E3634A-05B**S E R V I C E****N O T E**Supersedes:
E3634A-05A**E3634A DC Power Supply****Serial Numbers: MY51240014 to MY99999999****Metal Strap Kit for tightening loose bumper and for fitting rear lock link in side-by-side rack mounting****Parts Required:**

March 27, 2013

Figure 1: Top view 3mm gap observed between two different chassis designs

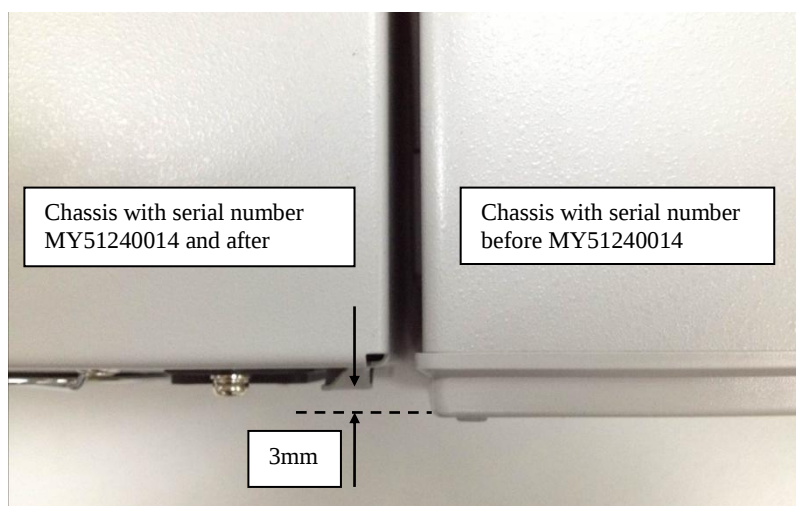
The chassis depth difference between the two designs is 3mm as shown in Table 1 and Figure 1 below.

Serial number range	Chassis depth
MY51240014 and after	345.2 mm
Before MY51240014	348.2 mm

Figure 2: Top view 3mm gap observed on rear lock link for side-by-side rack mounting

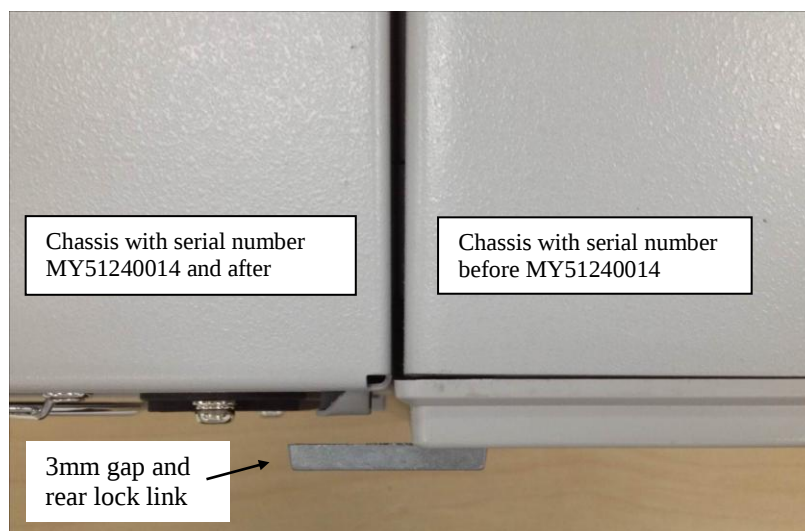
The 3 mm gap between the two different chassis may cause difficulties in securing them together using a rear lock link kit (part number 0050-2167) for side-by-side rack mounting as shown in Figure 2 below.

Use metal strap (part number E3631-07901), and stack the provided two metal straps together to form 3mm thickness and secure it with the provided screws on the rear lock link as shown in Figure 4 below.
